**Canyon Fuel
Company, LLC**

Skyline Mine

RE: Removal of NOG Shaft, CLEAN COPIES, Canyon Fuel Company, LLC, Skyline Mine,
C/007/005, Task #6077

Title: Removal of North of Graben Shaft

DWG. NO.: 2.7.1-2

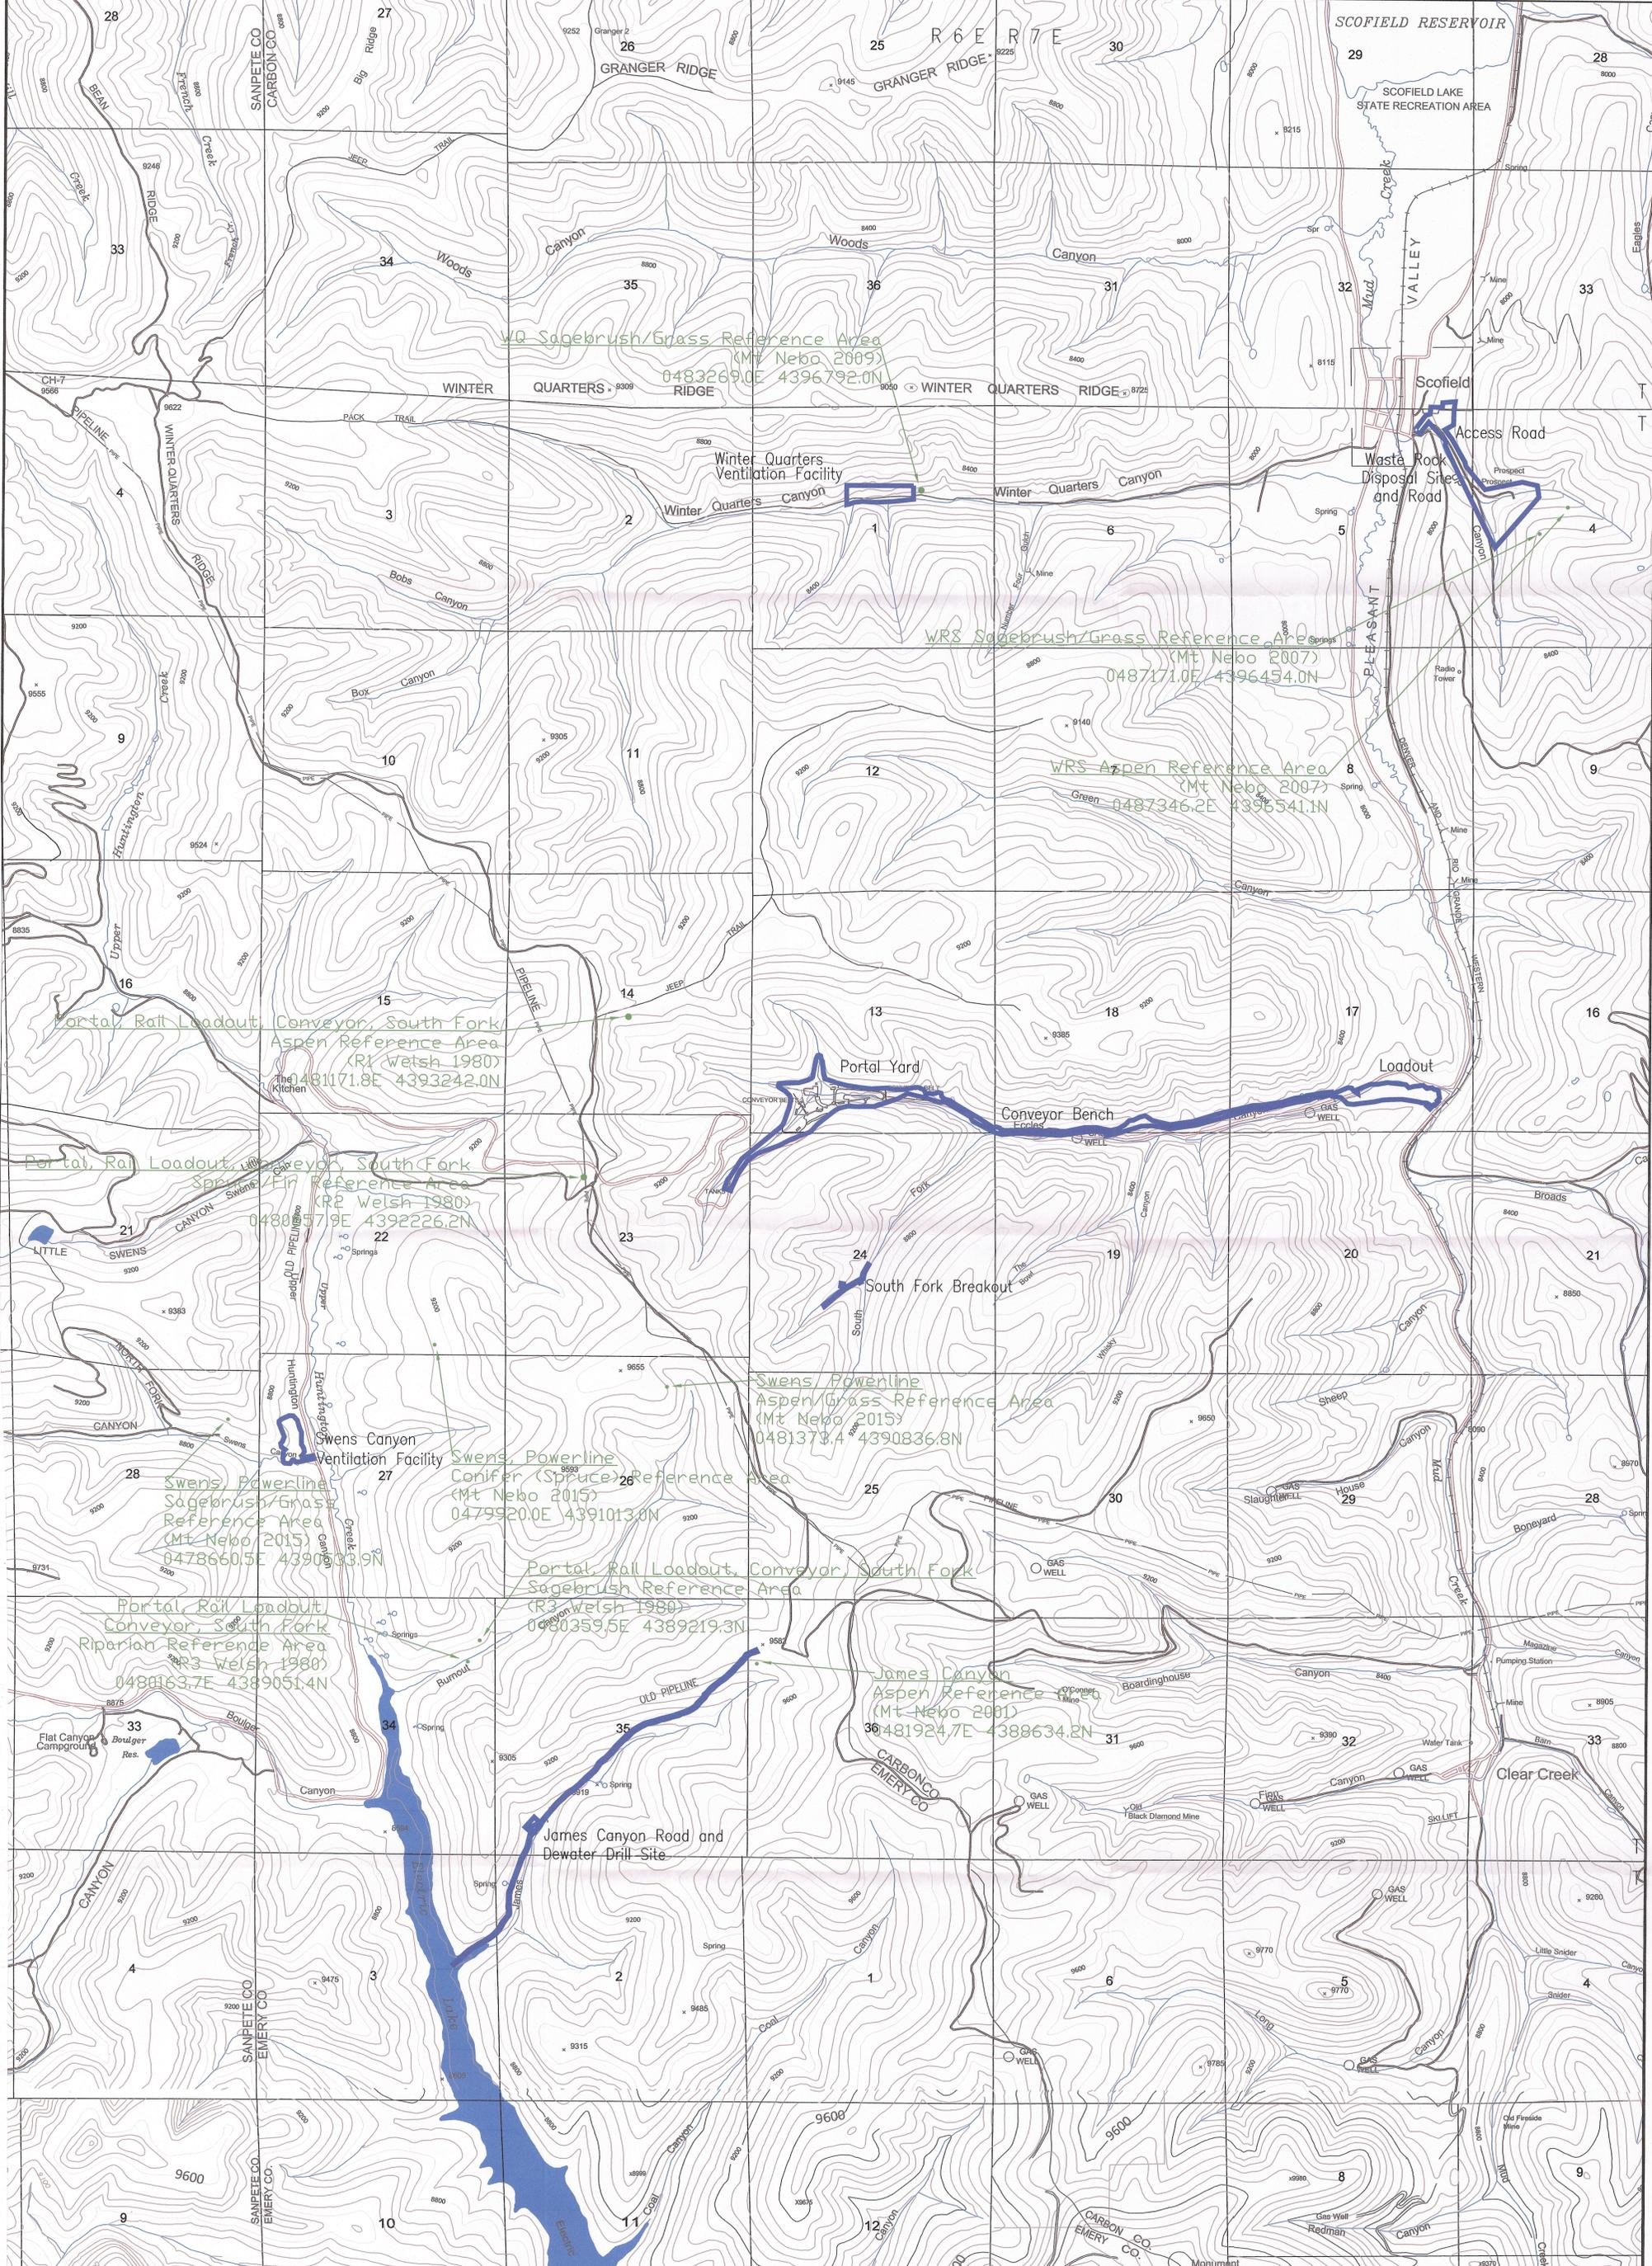
DATE	No.	REVISIONS	BY
5/4/2016	1	Correct reference sites from all areas	JR/GC
12/20/2019	2	Correct reference sites GPS coordinates	TE/GC
1/2/2020	3	Removed NOG shaft	TE/GC
